Water Research Laboratory | School of Civil & Environmental Engineering
NSW DPE State Significant Development Proposal
No. 7172: Hume Coal Project

Mr Doug Anderson | Principal Engineer – Groundwater and Modelling
11 February 2018

Comments on mining effects: groundwater

Figure 8.2

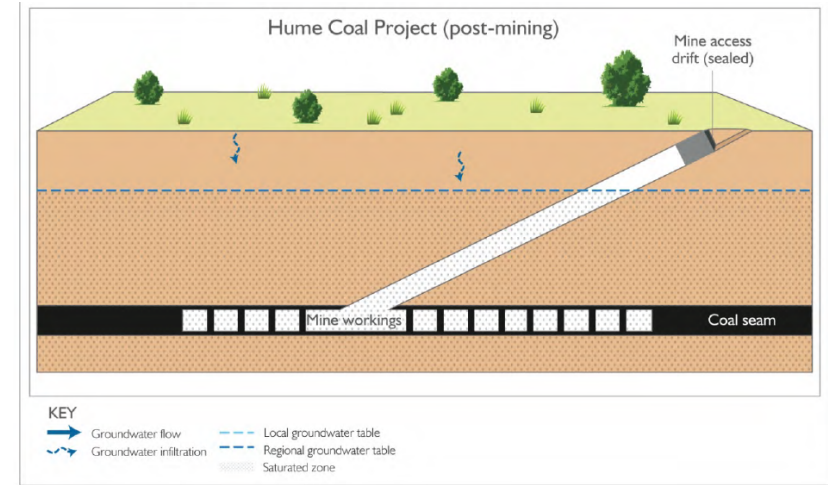
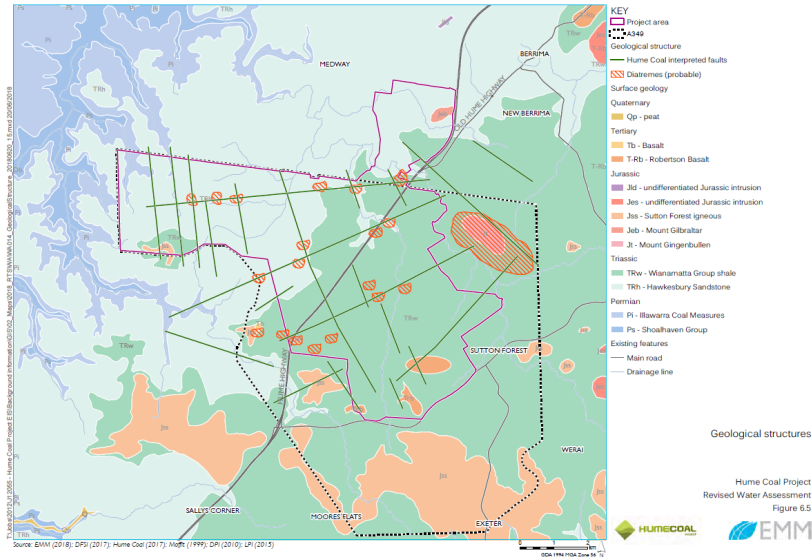
Joints, fractures and structures ignored:

- Numerous structures observed during desktop and field investigations
- Has a significant influence on groundwater flow but not represented in any numerical impact assessment model
- Hawkesbury Sandstone modelled as a homogenous slab of layered rock

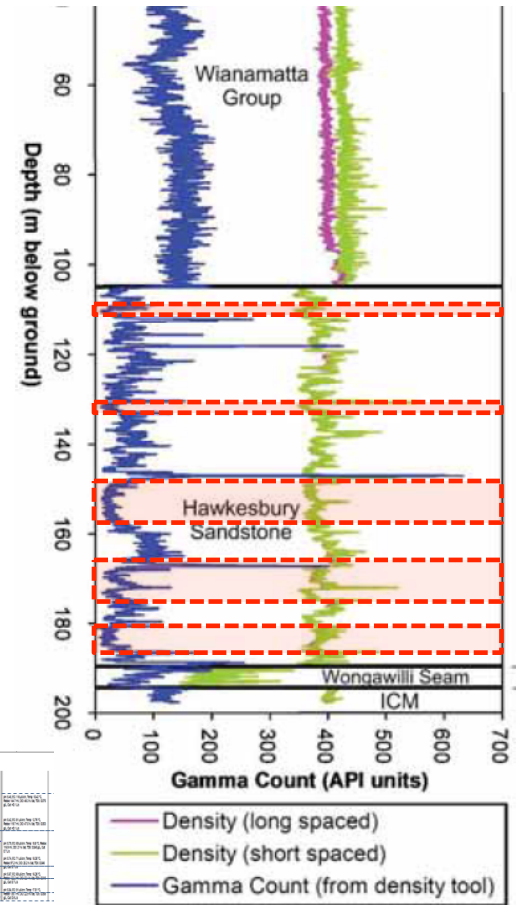
Numerical model layer conceptualisation:

- Extensive downhole gamma log data provides a clear evidentiary basis for subdividing the HS sequence into zones of higher and lower permeability
- WRL review of EIS geological log data finds:
 - Hawkesbury Sandstone in direct contact with coal seam in 80% of logs
 - Average thickness of layer 8 Narrabeen Group Rocks is about 0.4m not 2 m.
 - No geological basis for assigning model layers 6 to 10 the same hydrogeological properties because these layers represent different geological units (e.g. Hawkesbury Sandstone, Narrabeen Group, Farnborough Claystone and Wongawilli Group)

Figure 9.7

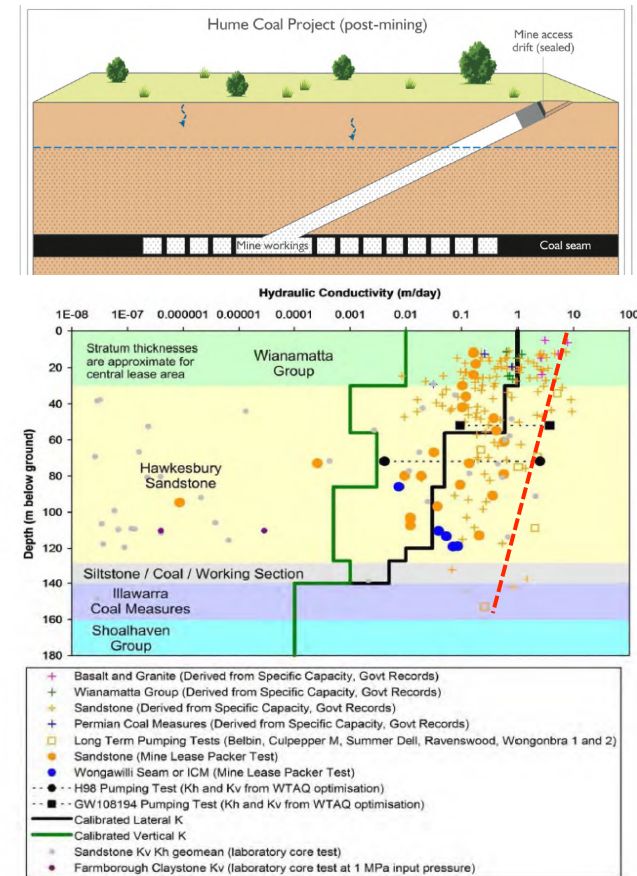
Interpretation of field hydraulic conductivity data:

- Ignored representative field-based determinations of high horizontal hydraulic conductivity (K_h) made from pumping tests and packer tests in nearby groundwater wells intersecting joints, fractures and structures.
- Specific yield assigned towards lower bound of literature values (i.e. drainage from sandstone pores with high clay content)
- Modellers' assumed K_v always 10 to 100 times lower than K_h (not realistic where sub-vertical joints and structures exist)

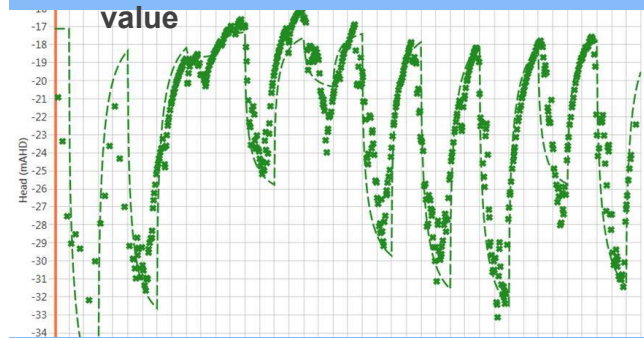
Model calibration not sensitive to Ss:

- Model essentially insensitive to aquifer Ss values (RTS, page 26, Vol. 2D)
- Ss values stated to be consistent with interpretations from pumping test data

- Drawdown predictions in groundwater systems are sensitive to the Ss value.
- The available observation data, model stress periods and calibration objective functions were insufficient to support a transient model calibration.
- Aquifer test interpretation sheets not published for review by NSW Government
- When modelled Ss values are consistent with aquifer test data but the K_h and K_v values are ignored in preference of lower rock matrix values (Issue #3) then the aquifer hydraulic diffusivity must be modelled incorrectly. Therefore, the model will under-predict the speed at which drawdown moves out into the surrounding formation through joints, fractures and structures. Consequently, impacts will occur at groundwater works prior to the EIS model predicting them.

Numerical prediction of drawdown, Hume Coal EIS

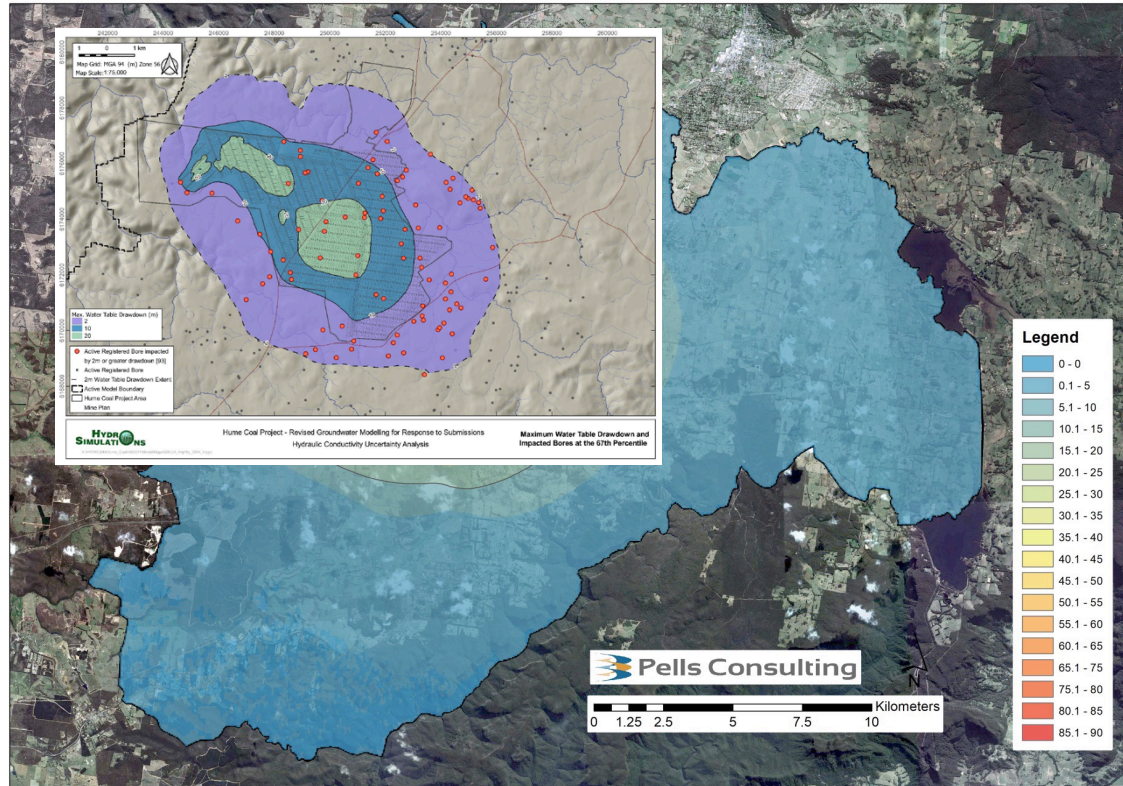
Note that this model:

- Predicts only 20m drawdown

Numerical prediction of drawdown, Hume Coal EIS

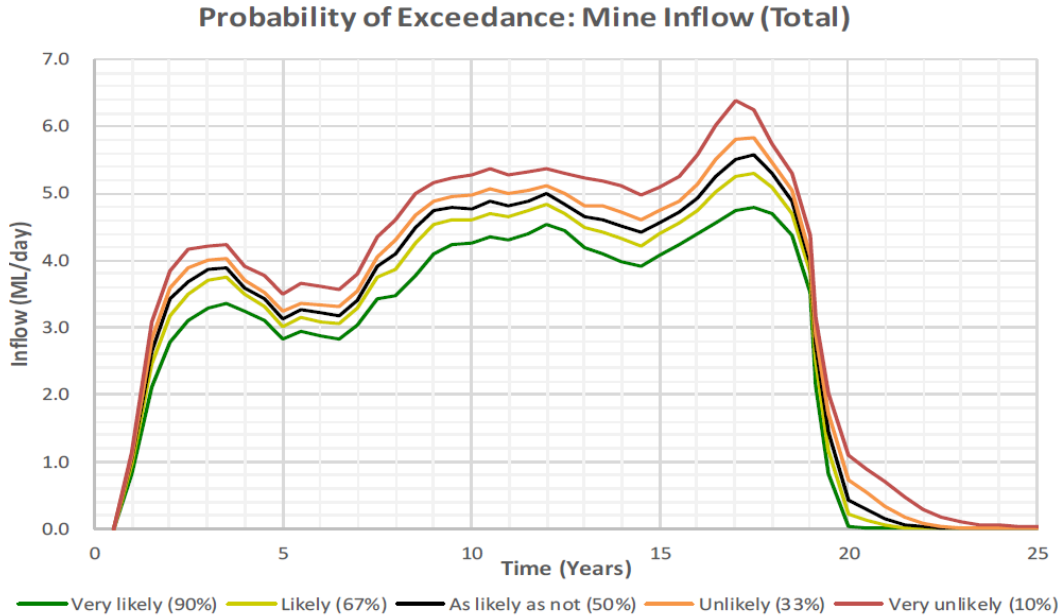
Note that this model:

- Predicts inflows similar to Berrima Mine, despite being:
 - 7 times larger
 - A new mine

Hume Coal EIS (Coffey 2016, Figure 5.6)

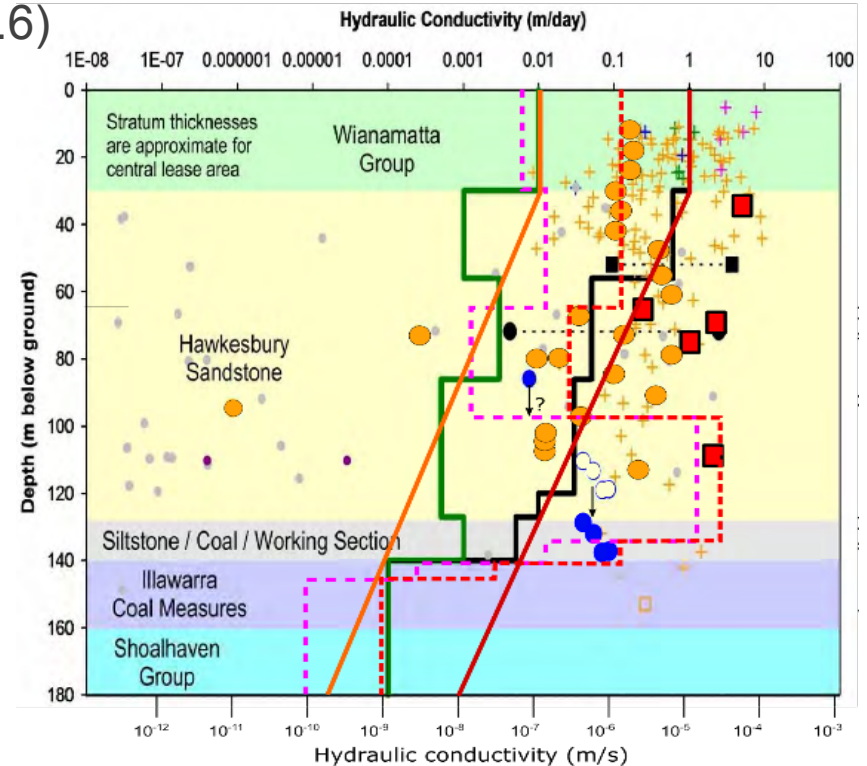
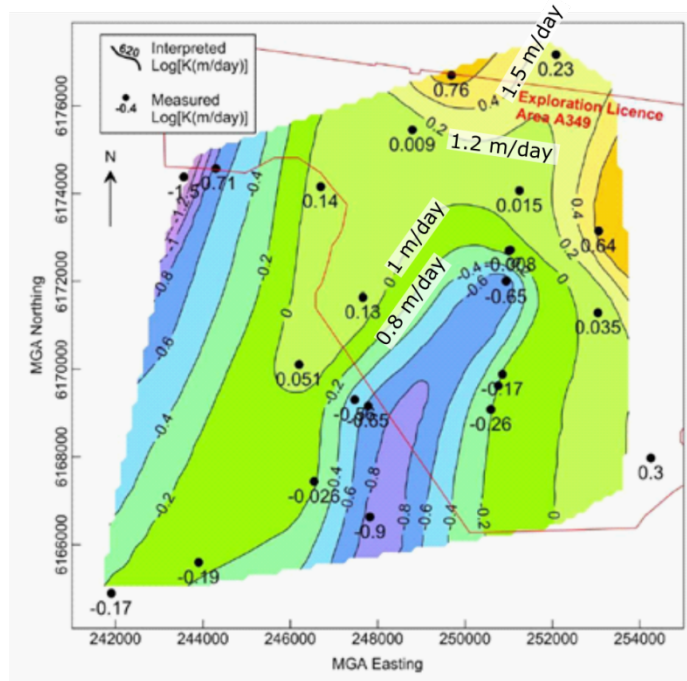
Reason 1: Conceptual model

Multiple lines of evidence suggest the presence of a high-yielding formation above the mine - an 'aquifer' in its true sense

This has not been represented in the EIS model
... at all

Figure 3 Groundwater model 'interburden' thickness

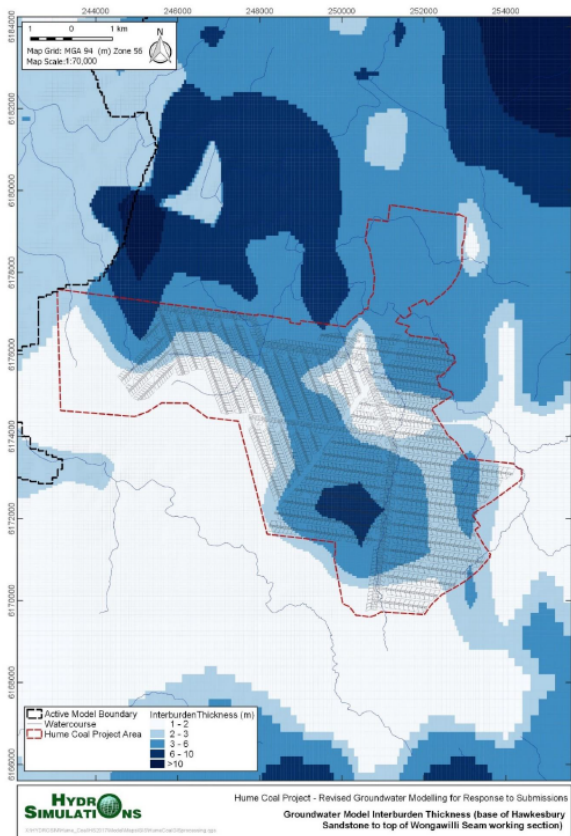
Reason 1: Conceptual model

McElroy and Bryan (1980):

> 200 borehole records from the pre-1985 investigations

direct contact between the Hawkesbury Sandstone and the Wongawilli Coal Seam in > 90% of the bores.

... TENUOUS

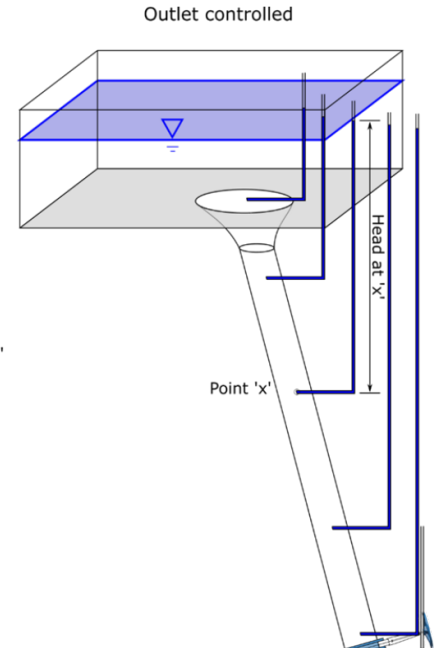
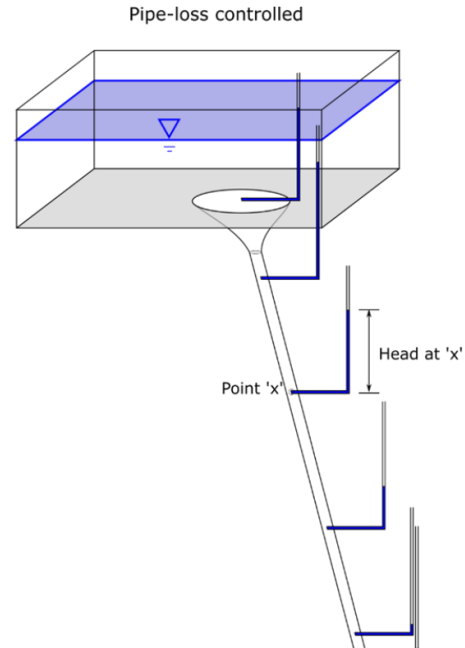
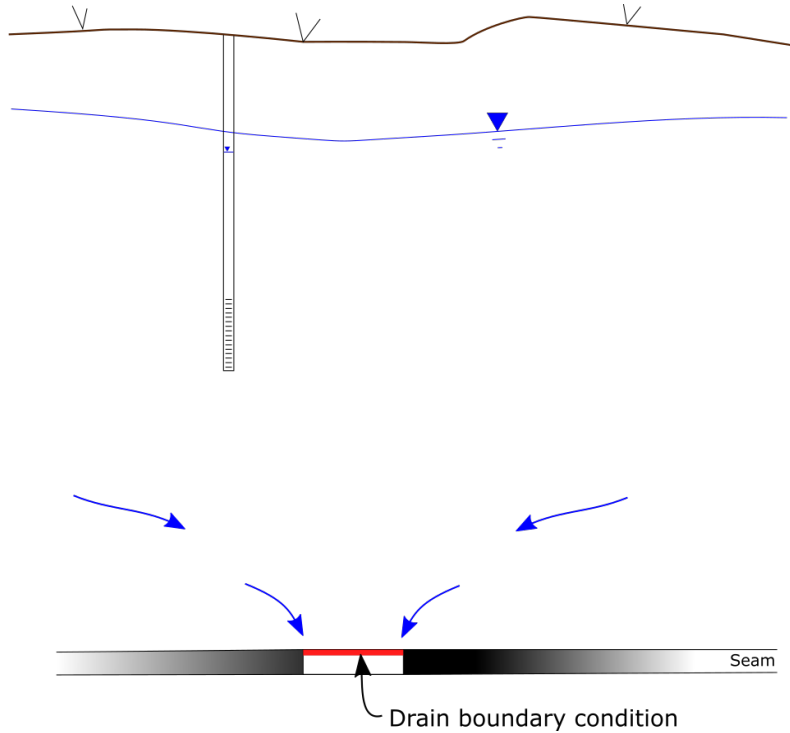
Predicted flows to the workings are represented as outlet controlled within the EIS.

A 'drain' boundary condition, with 'conductance' of 0.05 to 0.1 m²/day.

This controls inflows to the mine.

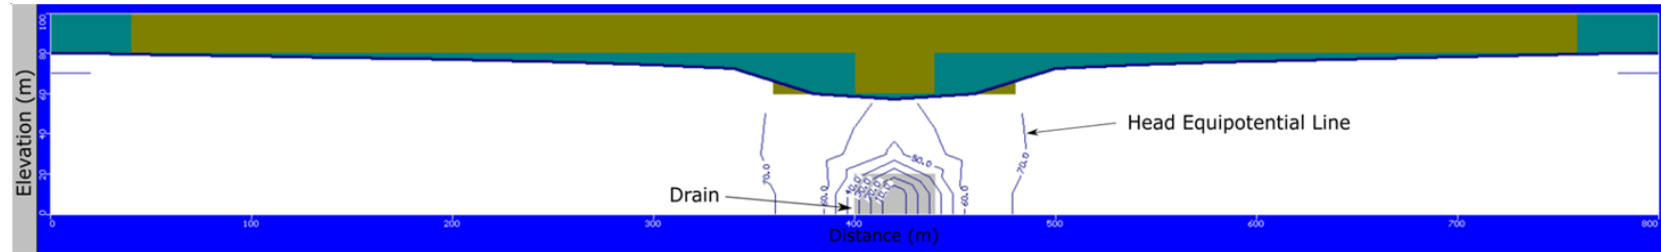
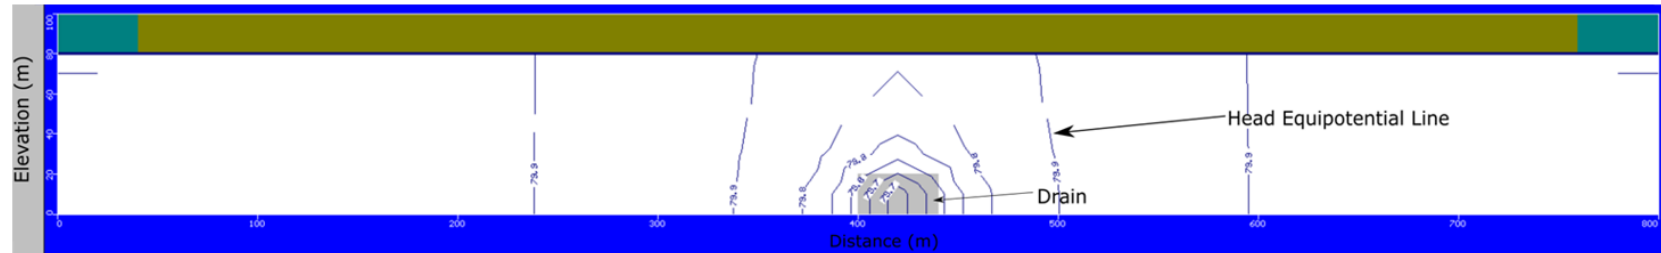
These two examples have equivalent discharge, but no drawdown for the outlet controlled case ...
